APPLICATION FOR DISPOSAL SYSTEM CONSTRUCTION PERMIT

SEPTIC SYSTEM DESIGN PLAN AND NOTICE OF INTENT FOR SHEILA STEVENS
 MAP 6B LOT 49 OVERLOOK DRIVE
 AMHERST, MA

DATE: 11.06.2007
 SCALE: 1"=30'
 DRAWN BY: ALAN WEISS
 REVISED: 04.18.2009 SEPTIC
 DRAWING NUMBER: 107-2868-0917

To: Ellen Bokina, Amherst Town Sanitarian
From: Alan Weiss, Cold Spring Environmental, Inc.
CC: Kieth Kanetta, Realtor and Sheila Stevens, owner
Date: 04.27. 2009
Re: Lot 49 Overlook Drive

Alan Weiss
Lot 49 Overlook Dr.
Plan 11.06.07
Back to ConCom
2 Trenches rather than 3

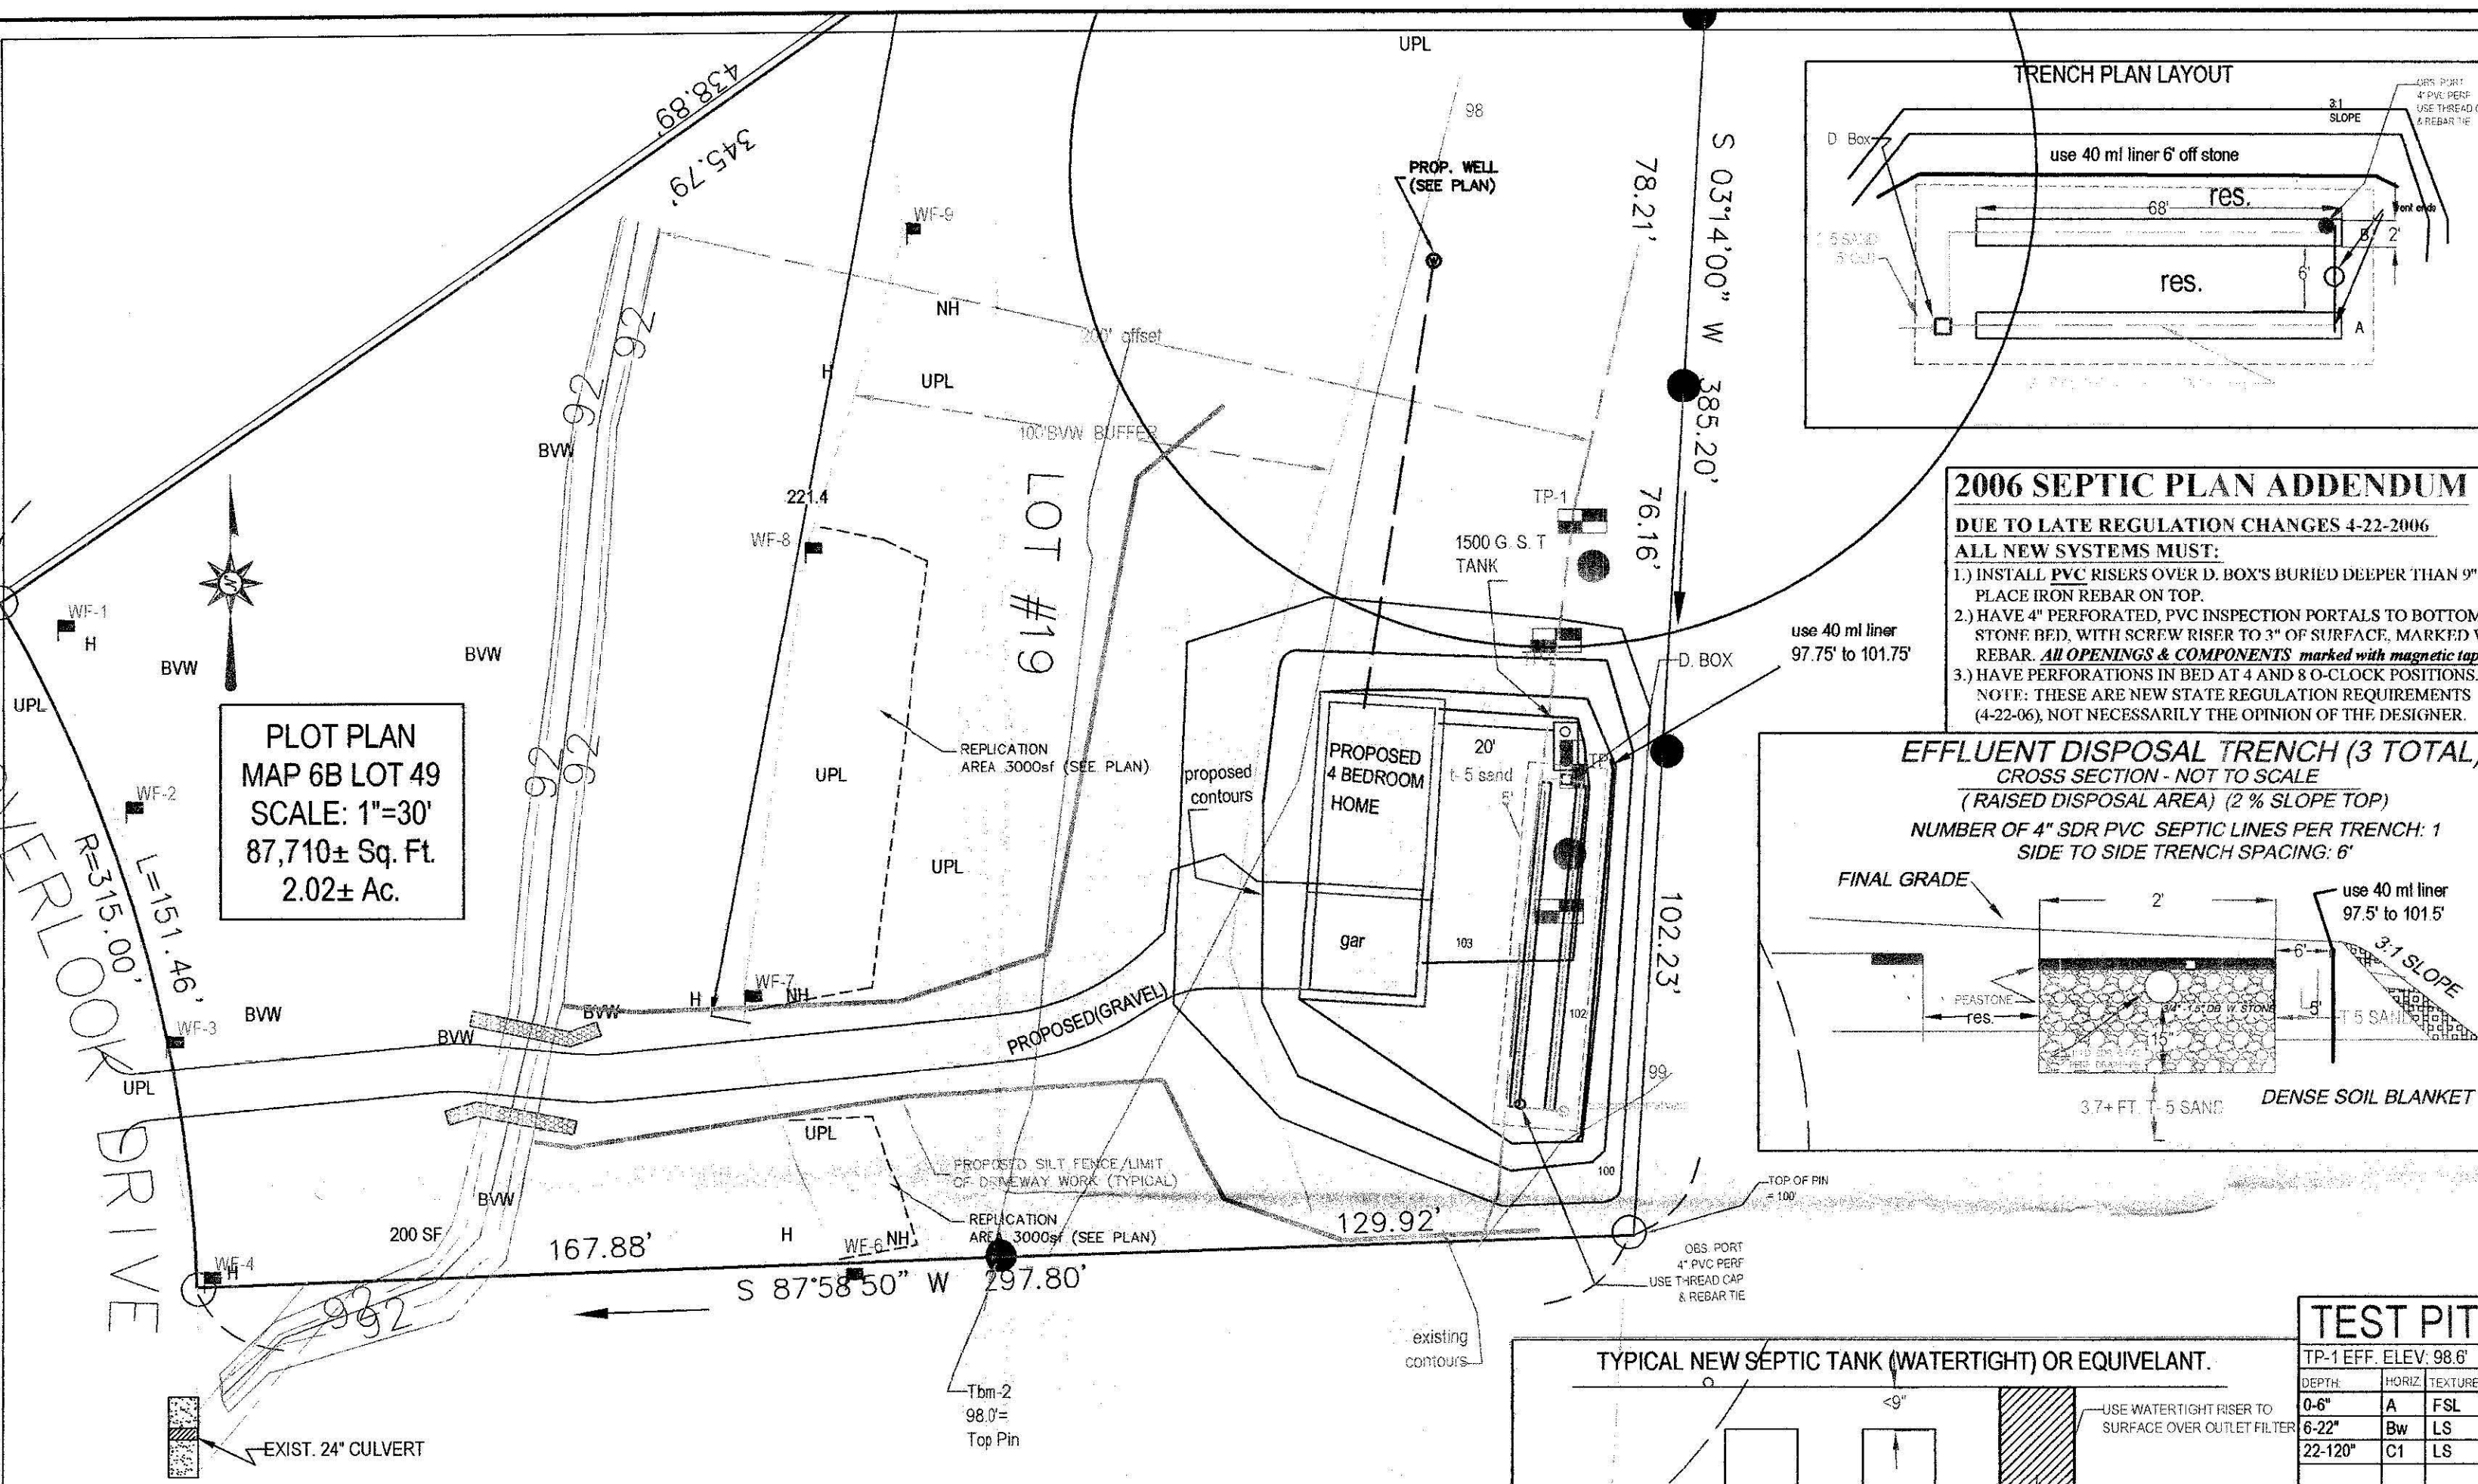
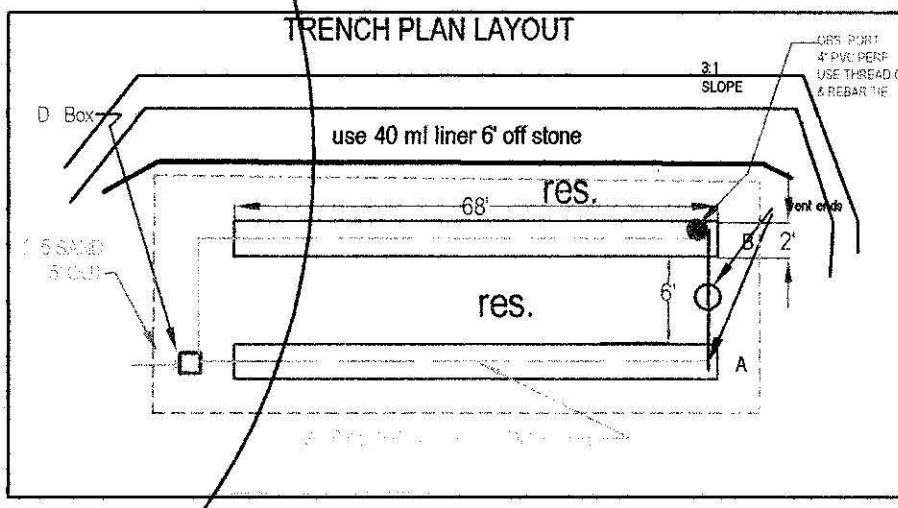
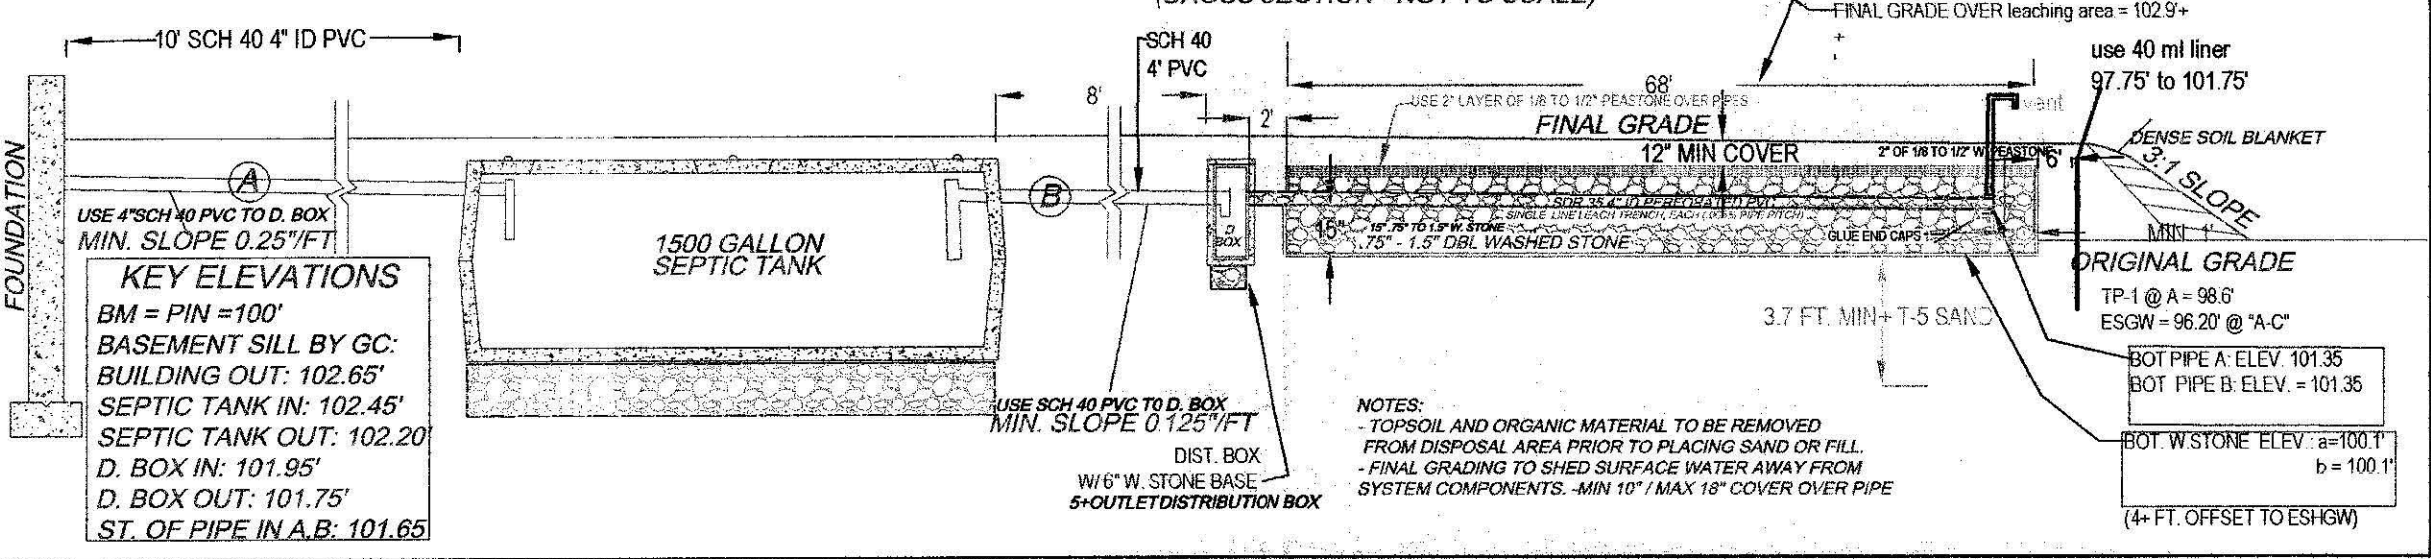
In synchronization with revisions forwarded to the MADEP and Amherst Conservation Commission, Please find the revised septic plan for the abovementioned lot that was approved by you last season but not yet constructed. The plan now uses two trenches not three in order to save fill and maximize proper resource area offsets (it remains a 4 bedroom plan). The proposed well location has also been revised.

- 4 BR X 110 GPD /BR = 440 GPD (required)
 -USE Two TRENCHES: 2' WIDE X 68" LONG WITH 15° OF 3/4" TO 1 1/2" DBL WASHED STONE BELOW INVERT
 - BOTTOM AREA: 2' W X 68" L X 2 TRENCHES = 272 SF.
